## **Appendix D      Landscape Establishment Monitoring Checklist**

TO :	Distribution List	DATE	19 December 2019
FROM	Dr. Priscilla Choy	SHEET 1 OF	1 + 24
REF. NO.	WL/MA12014/Corres/Out/DCVJV_it191219audit191129_v1		
	Contract HY/2011/09		
	Hong Kong-Zhuhai-Macao Bridge		
SUBJECT	Hong Kong Link Road-Section between HKSAR Boundary and Scenic Hill		
	<b>Site Audit for Landscape &amp; Visual Mitigation Measures during Establishment Period on 29 November 2019</b>

Environmental Monitoring and Audit  
Landscape and Visual Audit Checklist (Establishment Works)  
Contract No. HY/2011/09  
Hong Kong-Zhuhai-Macao Bridge  
Hong Kong Link Road – Section between HKSAR Boundary and Scenic Hill

Photo 4

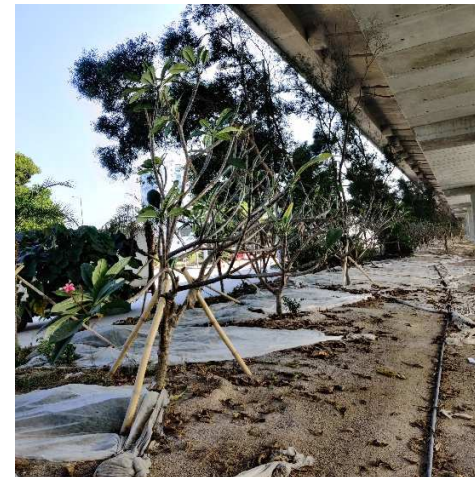
Signatures: Shrubs and replace them if confirmed dead. (photo 4 and 7)
